**Addendum #1**  
City of Portsmouth  
Portsmouth, New Hampshire  
Public Works Department

**MAPLE HAVEN DRAINAGE IMPROVEMENTS**  
**Bid #38-11**

5. The attached drawing Sheet C-9, *Winchester Street Ext. Plan and Profile*, revision 1, dated June 7, 2011, replaces the original Sheet C-9. The following changes were made within the U.S. Route 1 right-of-way based on comments received from the New Hampshire Department of Transportation:

TITLE:  
**WINCHESTER STREET EXT. PLAN & PROFILE**  
 STA. 90+00 TO STA. 99+98

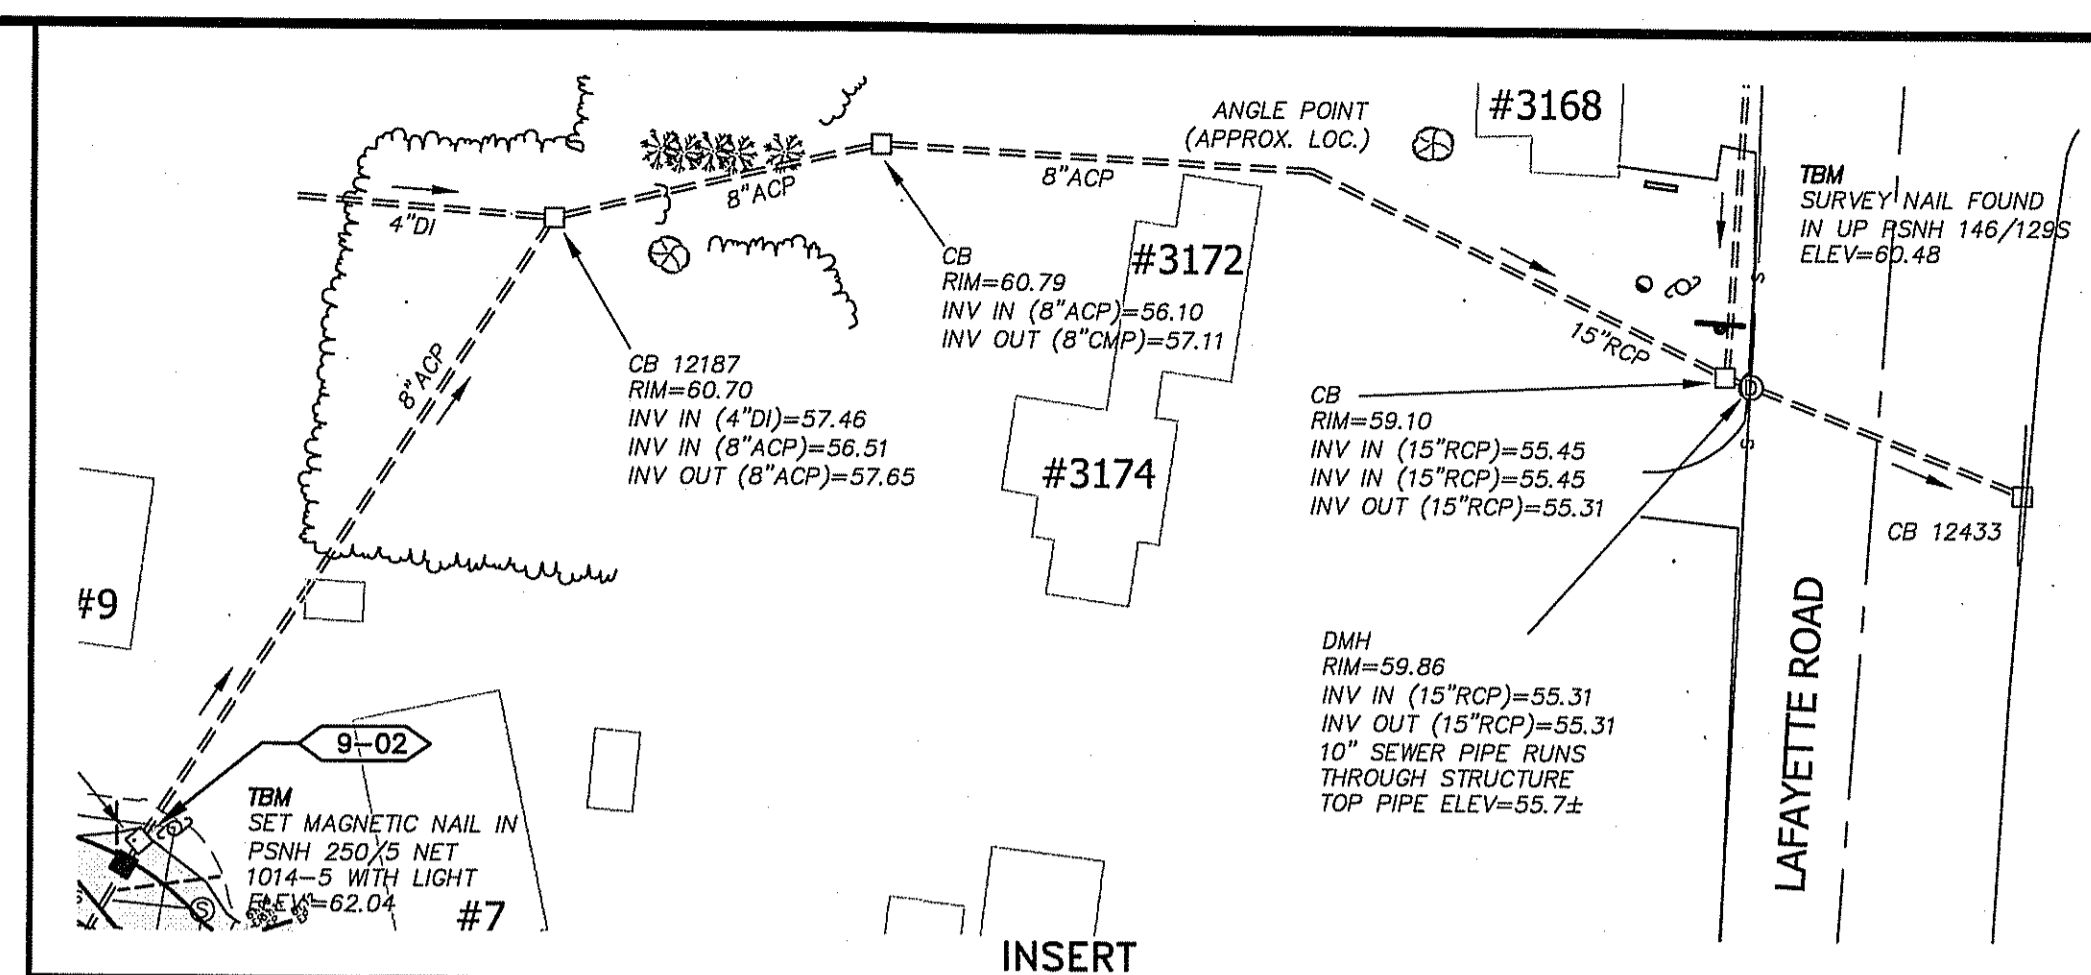
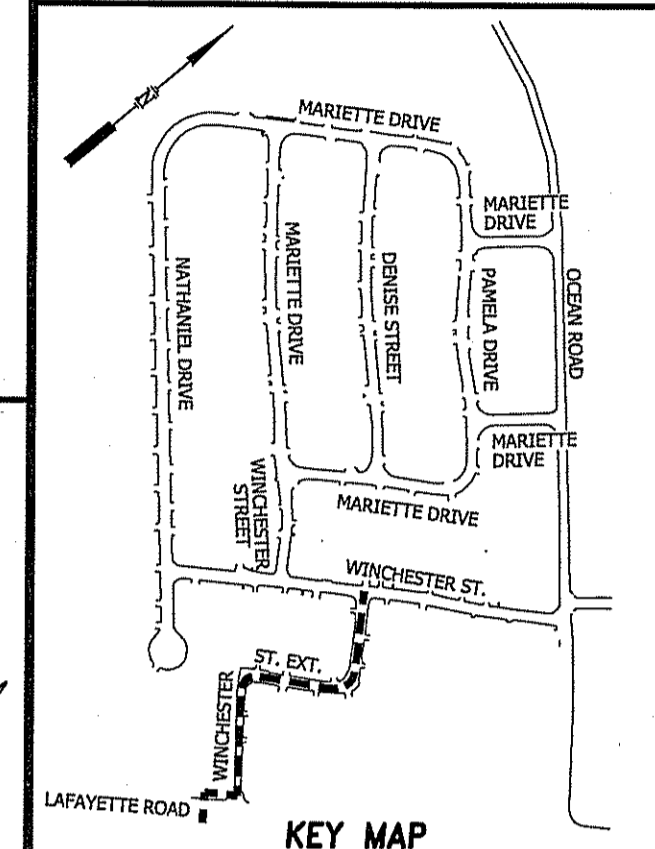
- The pipe crossing U.S. Route 1 is changed to 18" Polypropylene HP (SaniTite) pipe.
- The Type C catch basin is eliminated.
- Steel flared end sections and stone fill are added to the pipe ends on the west side of U.S. Route 1

- 9-11 REPLACE 12" CMP CULVERT. CONTRACTOR SHALL SUBMIT A TRAFFIC CONTROL PLAN AND SIGNED PACKAGE FOR APPROVAL BY NHDOT AND CITY OF PORTSMOUTH. CONTRACTOR SHALL FURNISH, INSTALL, MAINTAIN AND REMOVE CONSTRUCTION SIGNAGE. LIMIT OF PAVEMENT REPAIR (8" MIN.). SEE ROUTE 1 UTILITY CROSSING DETAIL (SHEET C-18)

- 9-12 INSTALL "NO OUTLET" SIGN
- 9-13 INSTALL GALVANIZED STEEL FLARED END SECTIONS AT END OF EACH 18" PIPE. INSTALL APPROX. 150 SF OF STONE FILL (D50 = 12", DEPTH = 18") ITEM 583.5 AT BOTTOM OF SWALE, AROUND FLARED END SECTIONS AND SIDE SLOPES OF SWALE TO 2.5' ABOVE INVERT.
